CC: Fabricio Ponce, P.E. Re: BLR – Windmill Road Proposed Traffic Study

Methodology Comment Responses

Methodology

CONCEPT PLAN

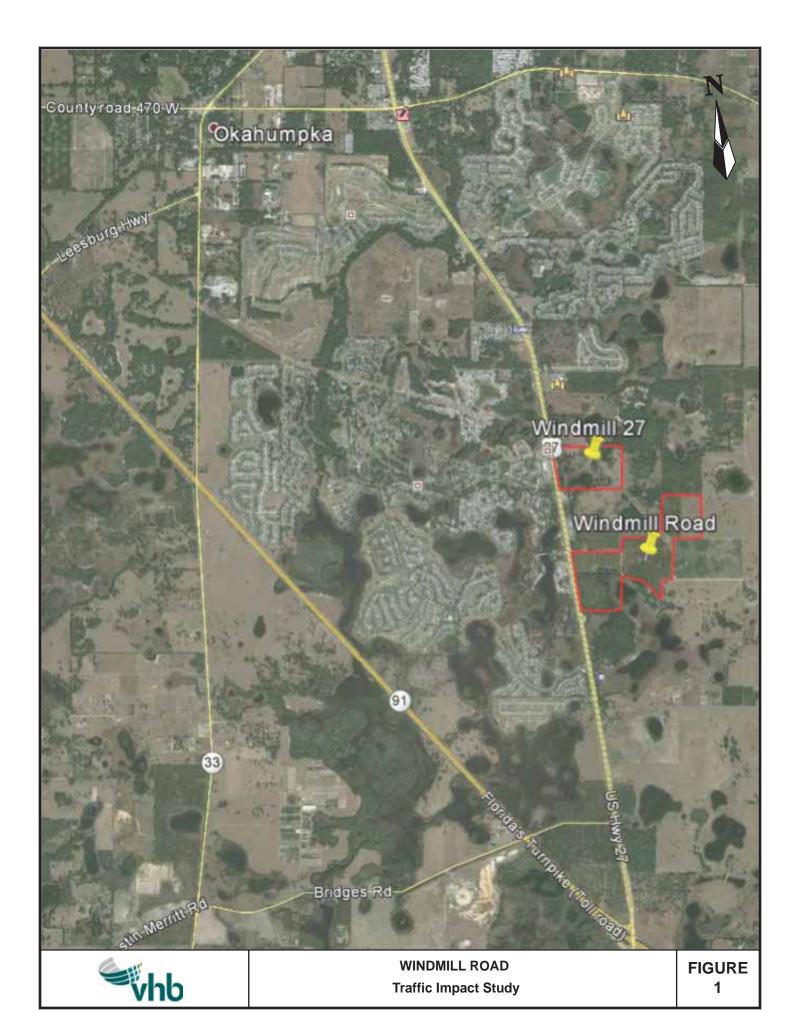
Comment #2 - The methodology states that the development program is 618 single-family dwelling units; however, the concept plan shows 344 single-family dwelling units. Please confirm.

Response: The traffic study is being prepared in support of a Future Land Use Map amendment; therefore, the maximum development potential of the site is used in the analysis to determine the worst case scenario impacts to the roadway network.
